Subject: Building Permit 29982 Amendment Application

I am submitting an application to amend building permit 29982, concerning remodeling work at 150 Brackett Road (lot 207-72).

150 Brackett Road Proposed Deck Stair Location Change

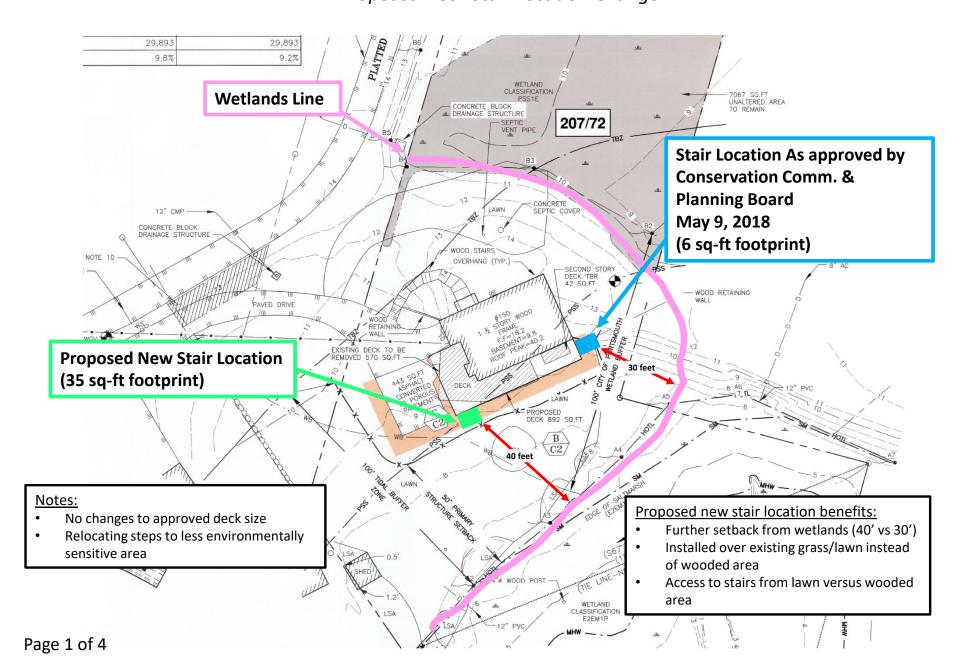
Throughout the project, we have been working with the most recent revision to the site plans, which have the deck stairs on the southern side of the deck. We made this change because the steps on the southern side of the deck presents a more favorable position as it is a less environmentally sensitive location. In this new location on the southern side of the deck, the stairs need to be larger to accommodate a landing (to allow for a 90-degree turn), and additional treads to account for the larger vertical distance to climb. As a result, the new steps would need to be 35 sq-ft total footprint. The approved stairs are called out as 6 sq-ft. This represents an increase in 29 square feet of footprint to approve.

In addition, I would like to make note of the improvements we have made to the site as a result of this project. When we purchased the house, prior to construction, there was a total of 823 sq-ft of impervious surface when accounting for the existing deck(s), and the asphalt-paved driveway. In the proposal we are making today, even accounting for the larger steps, we have reduced that impervious surface to 644 sq-ft, a net reduction of 22% of impervious deck/driveway surfaces when all is said and done.

I am asking for the approval of these steps in the proposed location as outlined in the informational packet that is enclosed with this letter.

Proposed Deck Stair Location Change

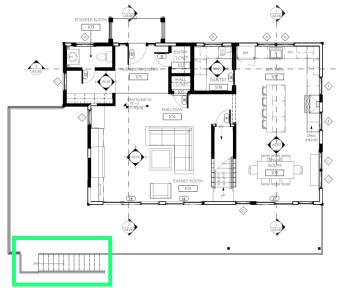
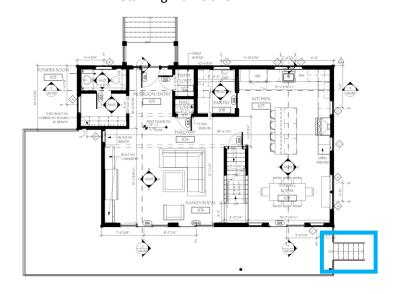
Proposed Location

Stairs approximately where blue chairs are shown

Approved Location

Stairs approximately where wood retaining wall is shown
